Fort Street Public School / Architectural Design Statement
Section 4.55 Modification

Department of Education [SSDA 10340] — REV 04 — 15/04/2021

Upper Fort Street, Observatory Hill, Sydney

/ Approved SSDA
/ MET Ground Floor Plan

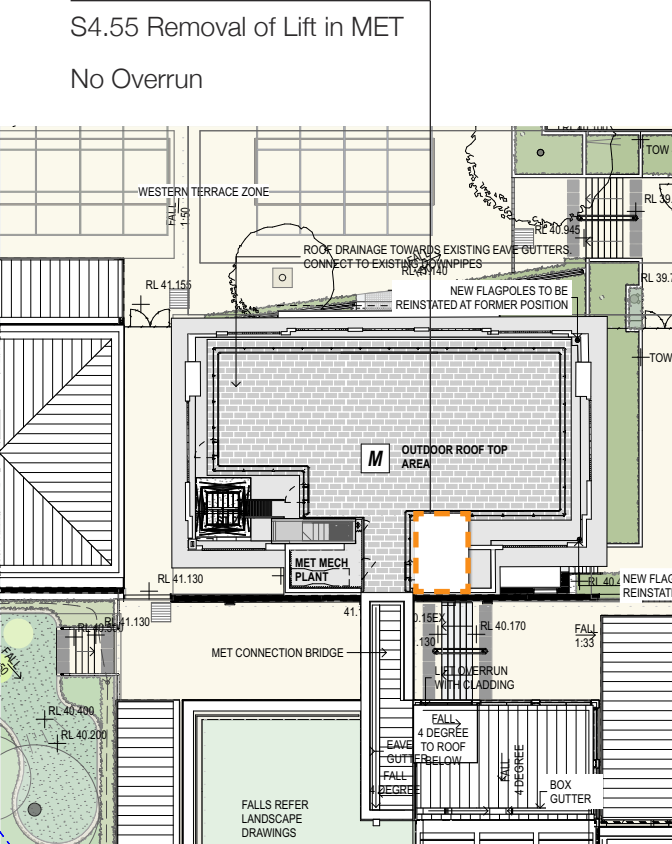
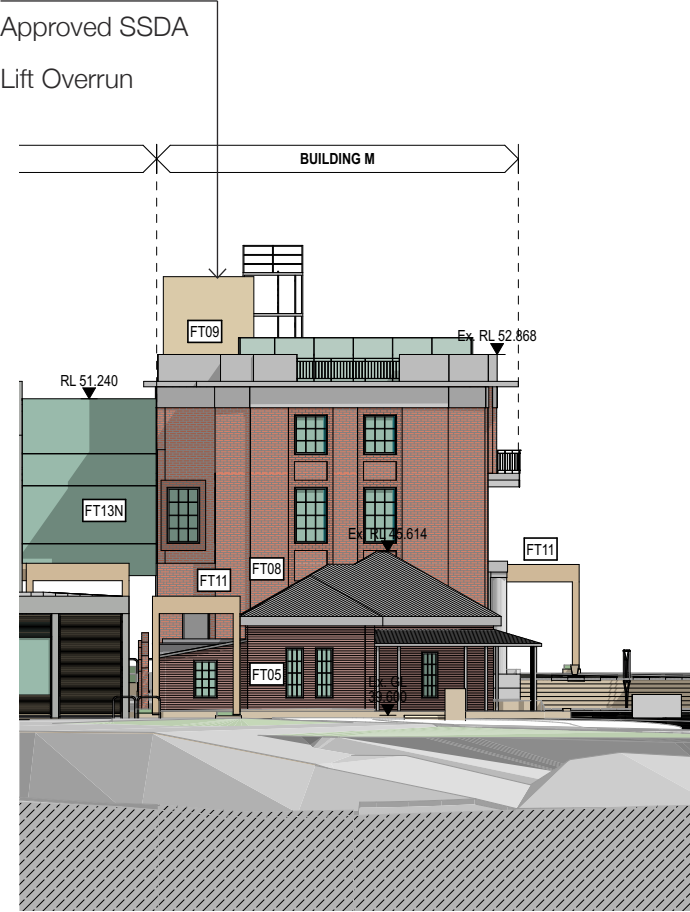
The approved SSDA proposes access to the MET rooftop playspace via a new lift within the footprint of the existing south east MET stair. Detailed investigations of the existing fabric and corresponding cost estimate highlighted associated risks. In conjunction, space planning amendments within Building J & H identified some potential efficiencies to liberate space for the relocated lift moving into Building J, hence avoiding cost and complexity risks. Through further consultation with the heritage and archaeological specialists, the more viable Building J location and corresponding raising of a portion of Building J was identified as the optimal amendment.

The existing south east stair is still to be removed as noted in the approved SSDA. However, where the lift was previously shown, a new flat timber floor will be introduced to allow for additional store rooms.

/ Approved SSDA
/ MET East Elevation

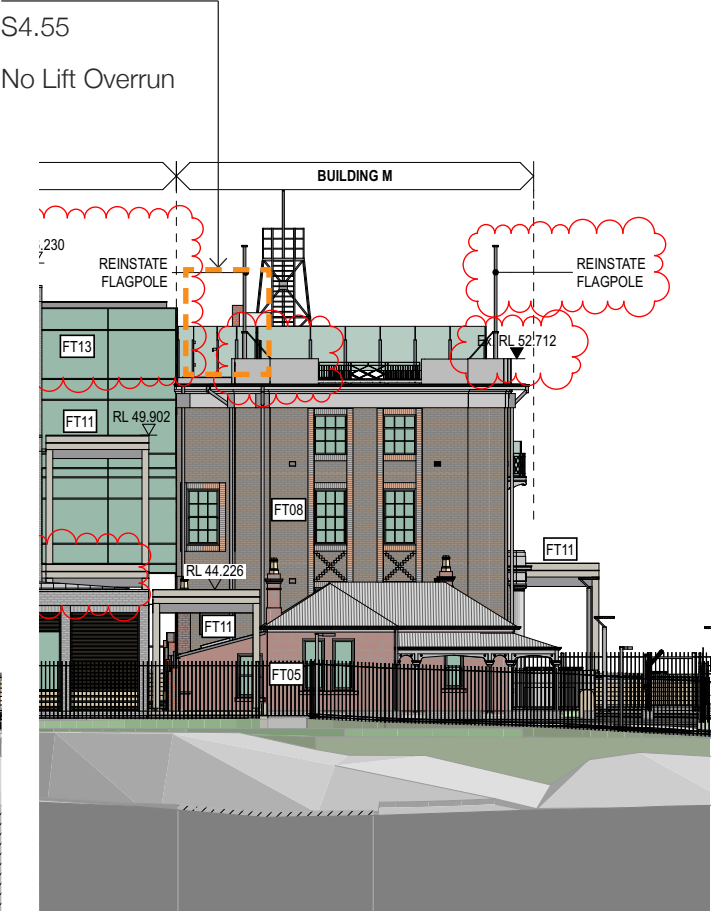
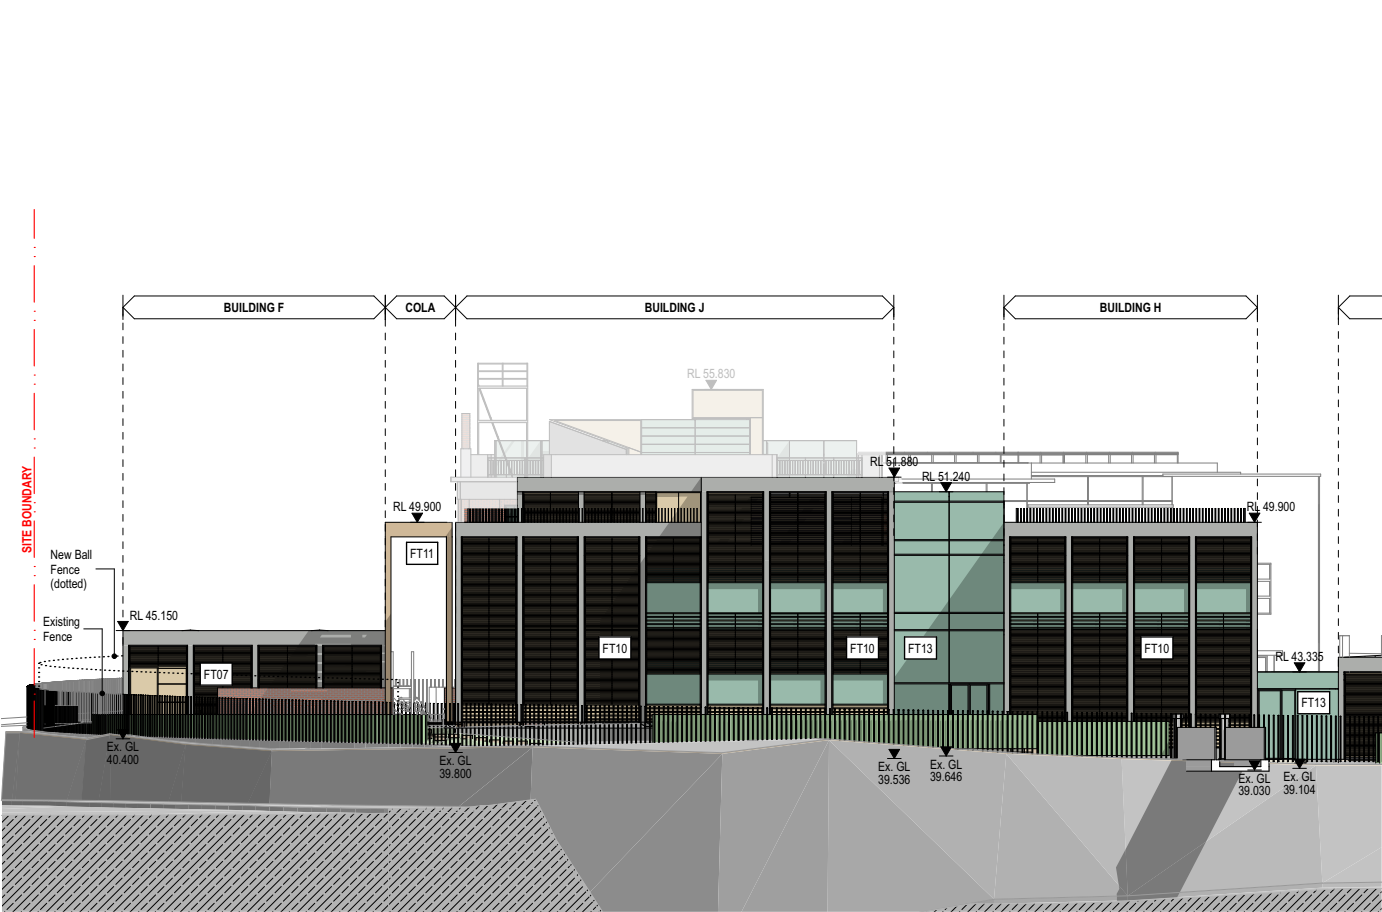
- Minimised heritage impact to existing MET building. This includes the removal of the lift pit excavation required with an introduction of a lift, and invasive works within this existing stair shaft.
- Improved amenity, legibility and visual impact to MET heritage building roofscape.

/ S4.55 - MET and Building J/H Level 3 Plan

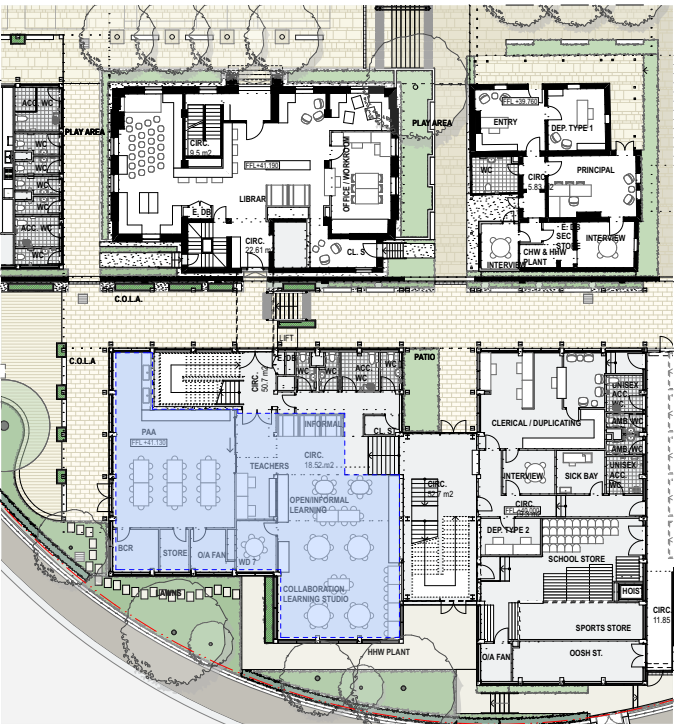
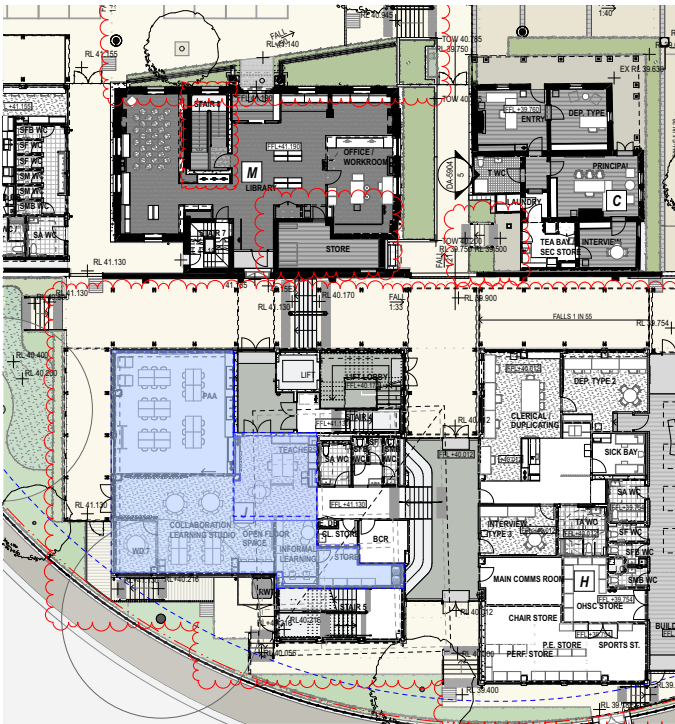
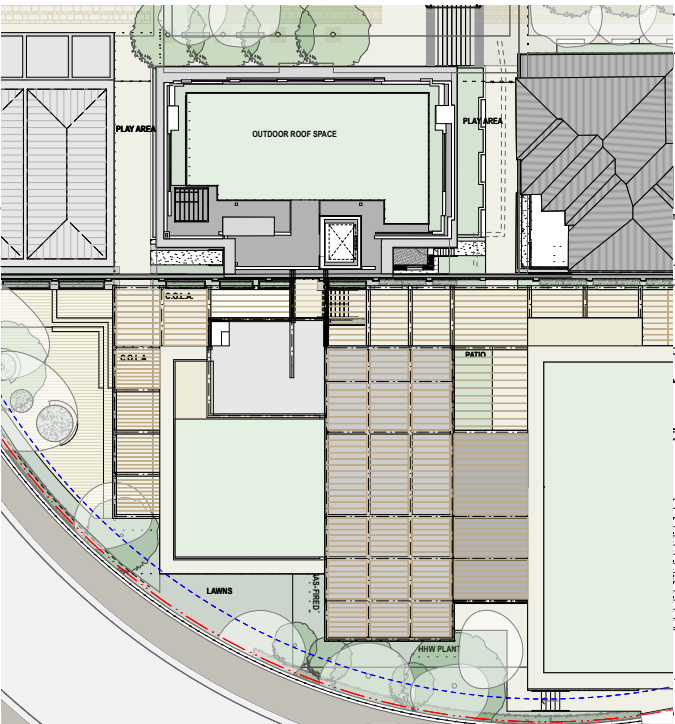
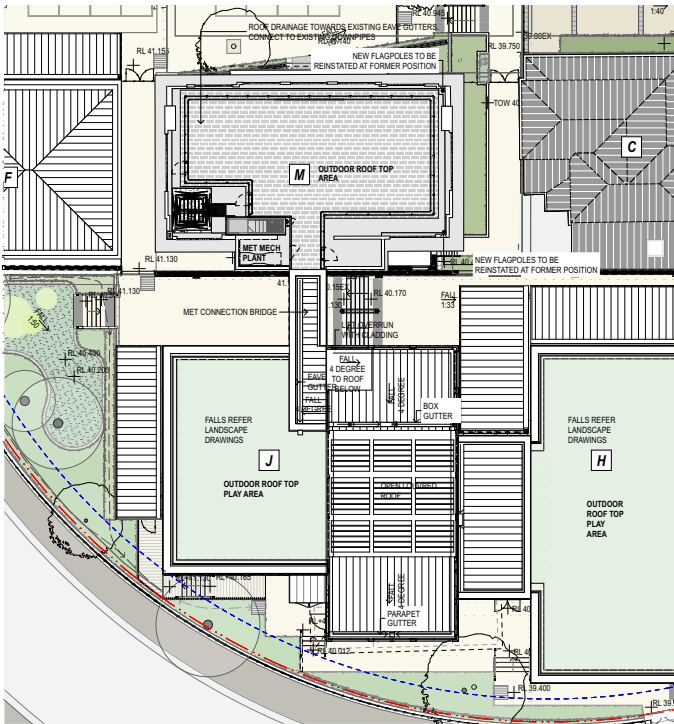
The lift to service the MET rooftop is to be relocated to building J. As a result, an additional level with lift and stairs from the approved SSDA is to be incorporated into building J.

According to the NCC two points of egress are required from every storey / compartment. This is applicable to the MET rooftop. The existing stair connecting Level 2 to the rooftop consists of non-compliant treads, risers and fixtures such as handrails and the like. Reconstruction of this stair would require highly invasive works due to spacial and heritage constraints. Hence the two new stairs for egress are to be provided within the adjacent Building J.

This has in turn provided opportunity to consolidate the building form and internal layouts to accommodate these 2 stairs within Building J. Firstly, the relocation of the Building J stair to the North East Corner allows for an opportunity to create a light filled circulation axis which provides views across the school site. This shift combined with the placement of the lift creates an improved and consolidated

circulation core for the campus. Secondly, the approved SSDA location of the stair between Building J and H is proposed to relocate to the south aligning with the North East Stair. This shift not only allows for compliant distances to the exits but also maintains a cohesive building form. The circulation corridor in place of the previously located stair is now proposed to accommodate a larger school entry foyer in front of the reception and tiered seating for informal activities, improving its amenity and quality of space.

The additional part-storey created within Building J provides an opportunity to relocate the mechanical plant to this level therefore increasing amenity to the rooftop playspace area on Level 2. An increase in the rooftop play areas is also provided.

/ South Elevation Building J/H

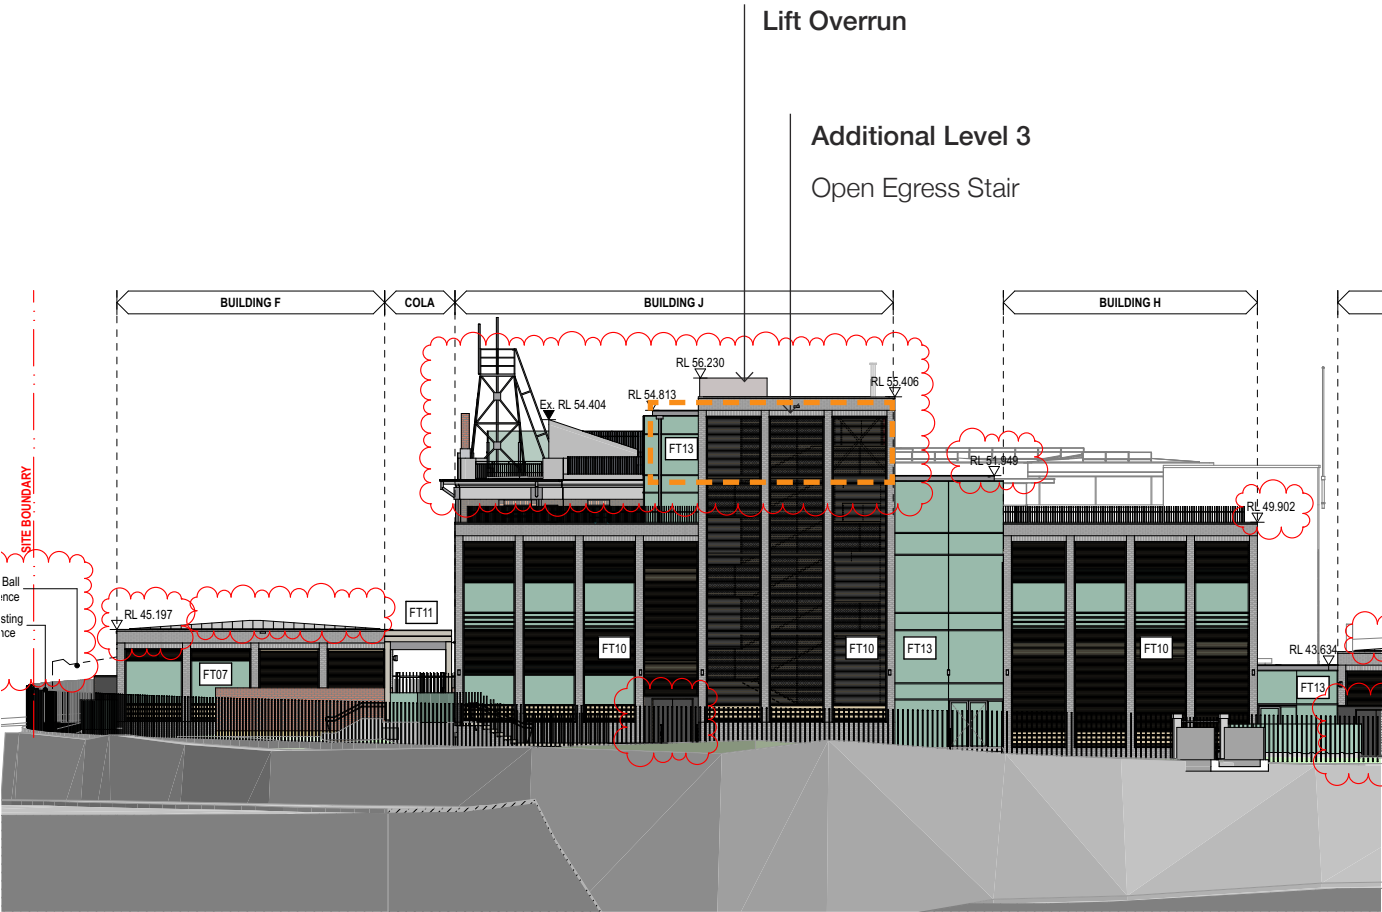
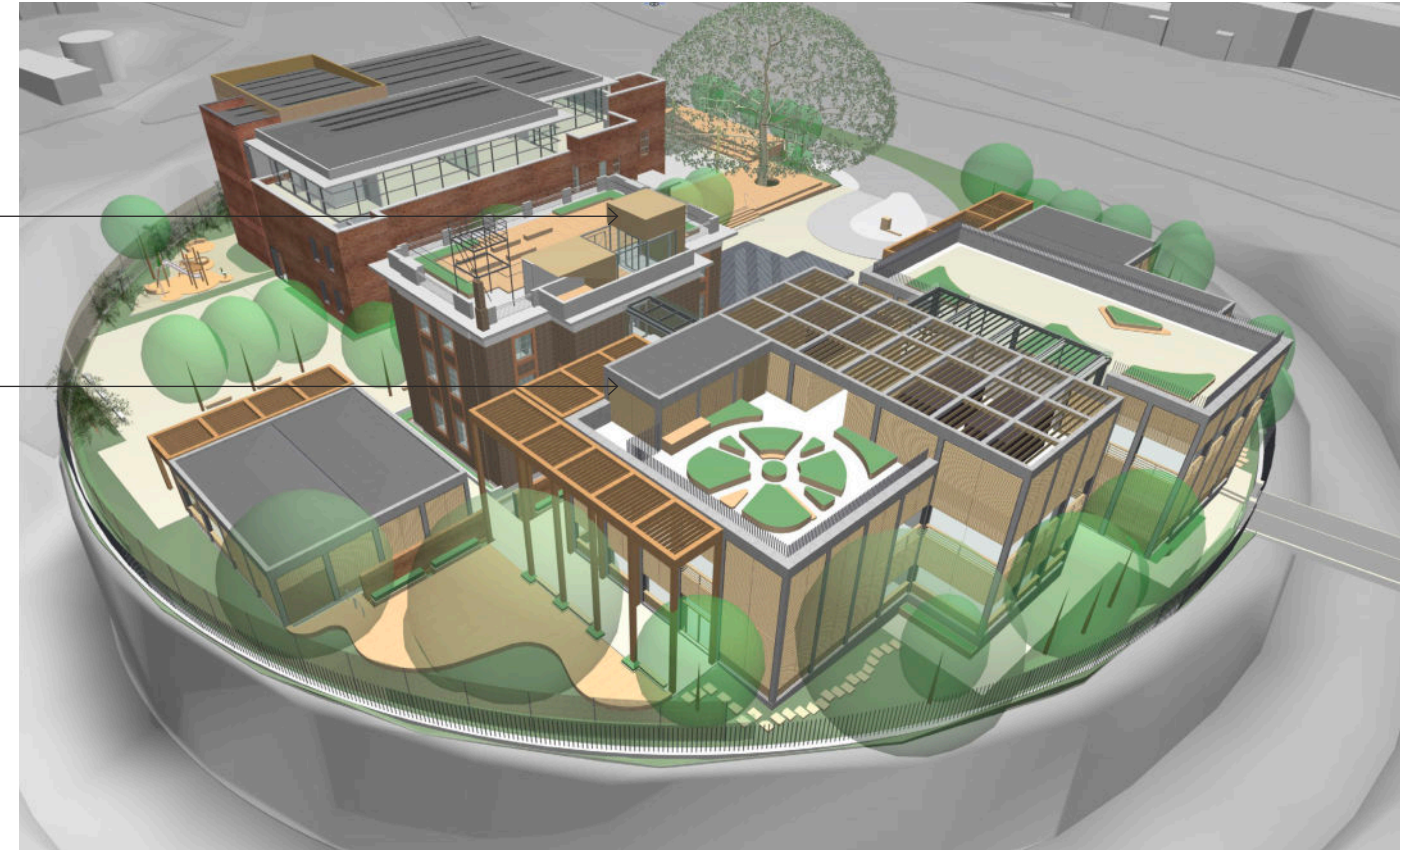
SSDA MET Lift location

Propose to remove/relocate

SSDA Building J Stair location

Propose to relocate

/ S4.55 - South West View

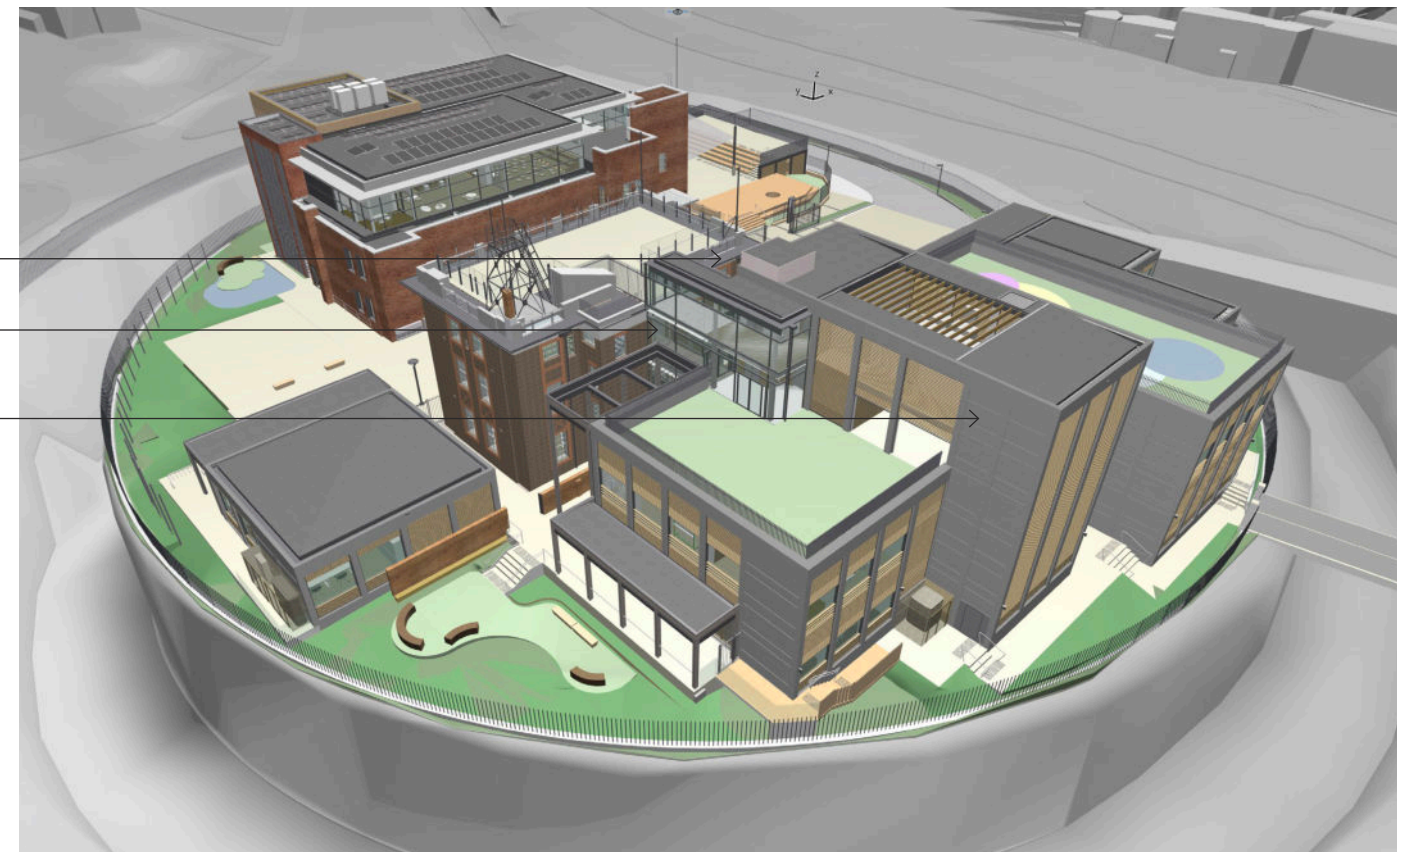
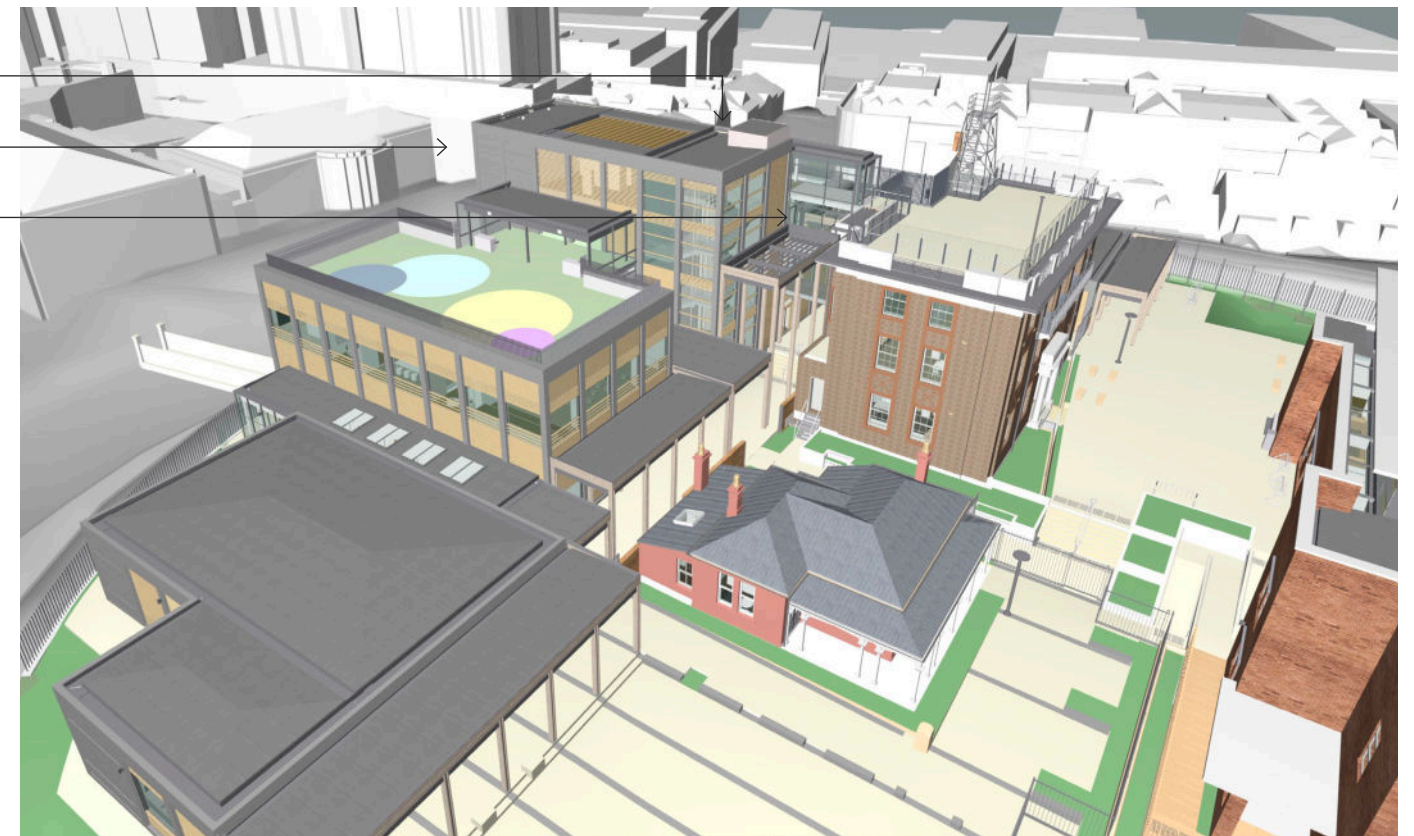
Proposed Lift and Overrun

**Additional Covered Walkway to
MET Rooftop**

**Additional Partial Level with
Stair**

SSDA MET Lift location
Propose to remove/relocate

Proposed Lift and Overrun
Additional Partial Level with Stair
Additional Covered Walkway to MET Rooftop
